City of Avondale Estates
Planning Architectural Zoning Board
Staff Review, Variances *

November 17, 2025, PAZB Meeting

Applicant: 278 Oak Holdings LLC: Jetha Wagner, Avila Development

Property Address: 136 Laredo Drive, 2968 Parry Street, 147 Oak Street, 2950 Franklin Street, and 2556 Franklin Street (Oak Parcel)

D)

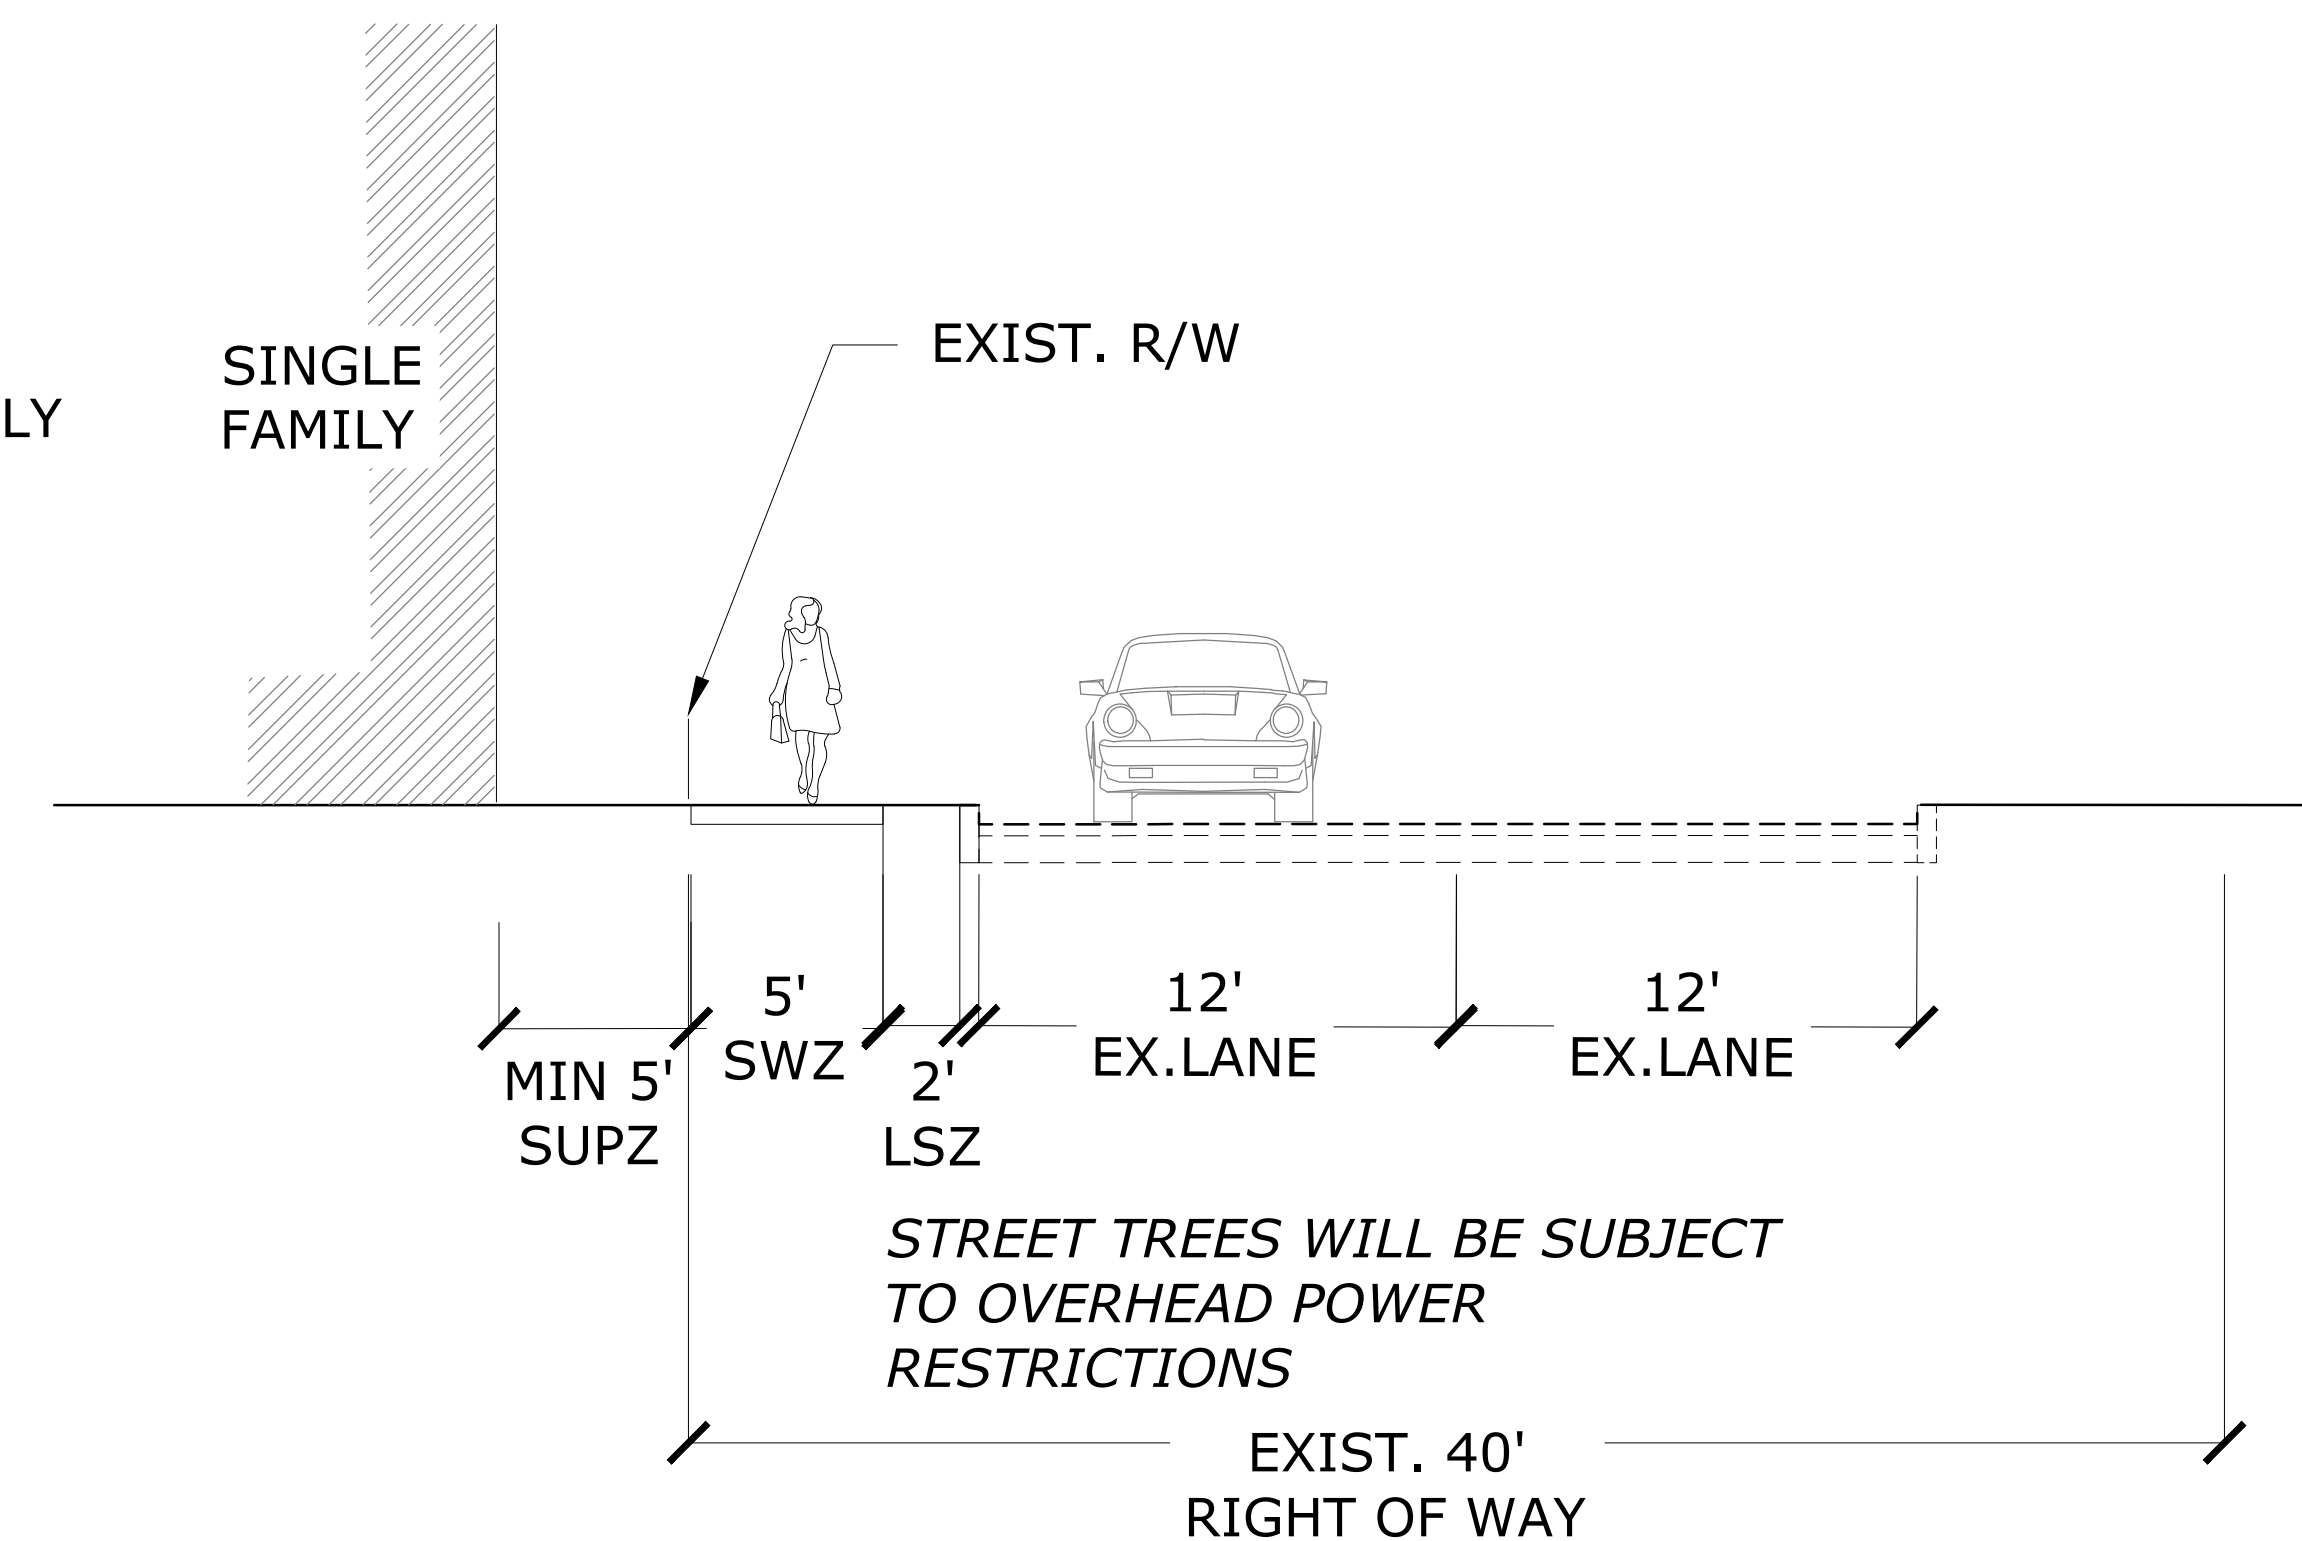
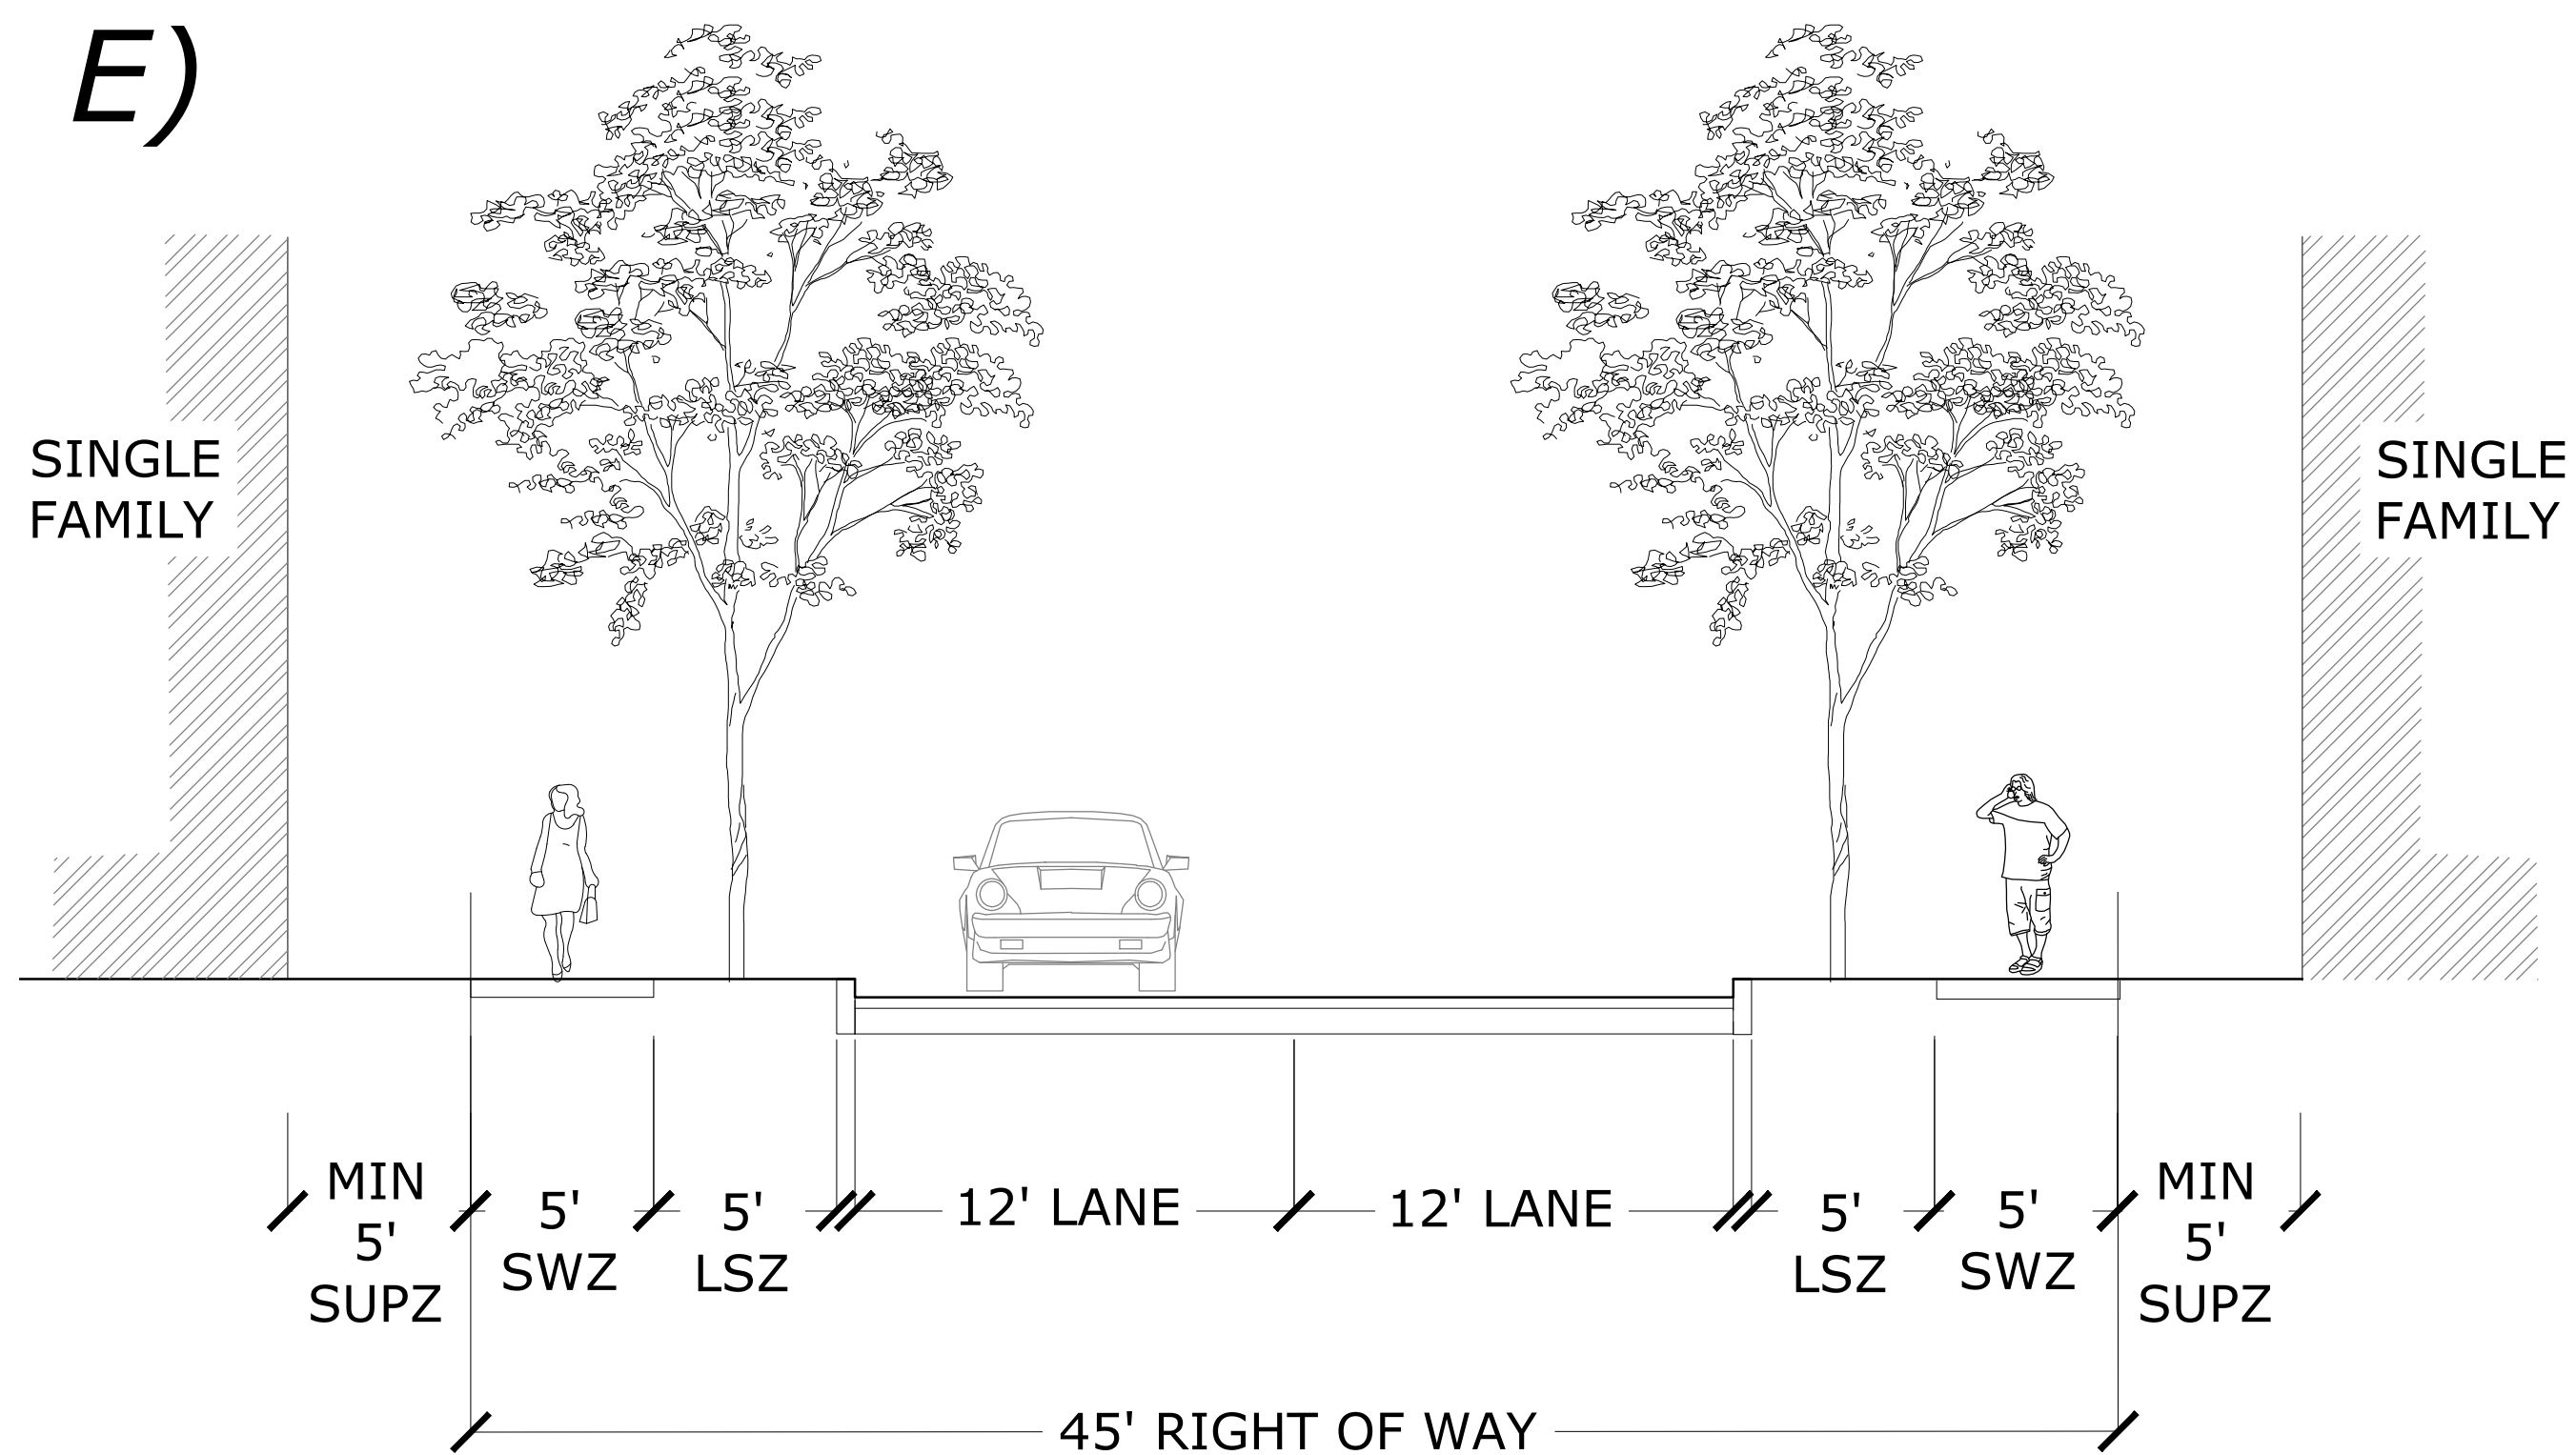
FROM: Figure 21-3.2.8.B.4.b and Table 3.2.8.E reduce type B2 street section from 60' ROW and 5' SUPZ to building face.

FROM: Figure 21-3.2.8.B.4.b and Table 3.2.8.E reduce type B3 street section from 45' ROW, 3 LSZ and 5' SUPZ to building face.

FROM: Figure 21-3.2.8.B.4.c and Table 3.2.8.E reduce type C1 street section from 55' ROW and 5' SUPZ to building face.

FROM: Figure 21-3.2.8.B.4.c and Table 3.2.8.E reduce type C2 street section from 40' ROW and 5' SUPZ to building face.

FROM: Figure 21-3.2.8.B.4.c and Table 3.2.8.E reduce type C1 street section from 55' ROW and 5' SUPZ to building face.

FROM: Figure 21-3.2.8.B.4.b and Table 3.2.8.E reduce type B1 street section from 72' ROW and 5' SUPZ to building face.

FROM: Figure 21-3.2.8.B.4.d and Table 3.2.8.E reduce type D street section from 40' ROW and 5' SUPZ to building face.
